Architectural Review Committee Staff Report Meeting Date: September 16, 2025

PETITION: Request for approval of architectural design

LOCATION: 6383 W Broadway, McCordsville, Vernon Township

Illustrative Architectural Exhibit

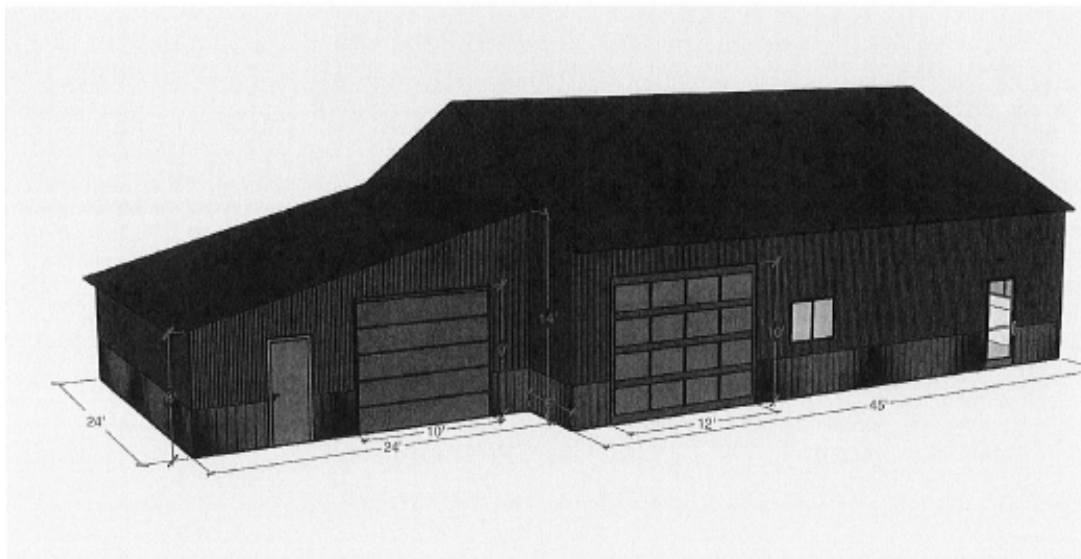
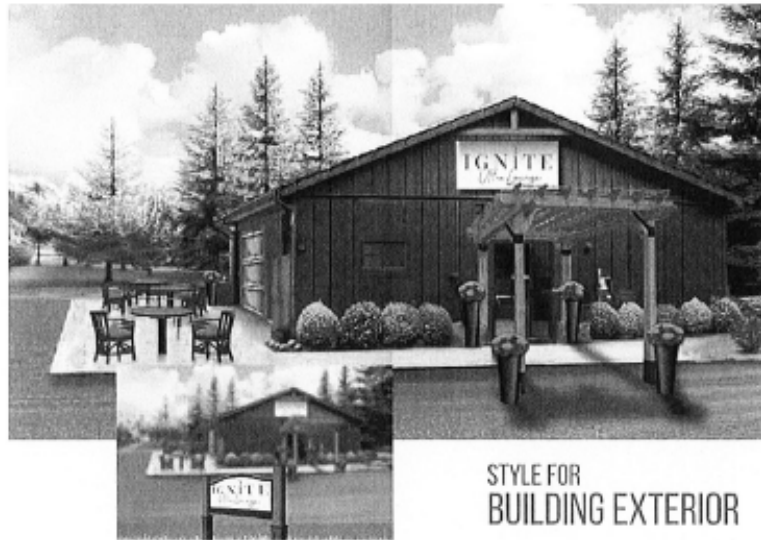
3. The north façade shall feature a covered porch, covered entry, or pergola, similar to that shown in Exhibit C-1. This feature shall utilize warm wood tones and materials.

7. The north façade gable shall feature a decorative detail similar to that shown in Exhibit C-1.
- B. All new primary structures on the property shall be required to meet the requirements of the Neighborhood Commercial Zoning District and the MCR-OL Overlay.
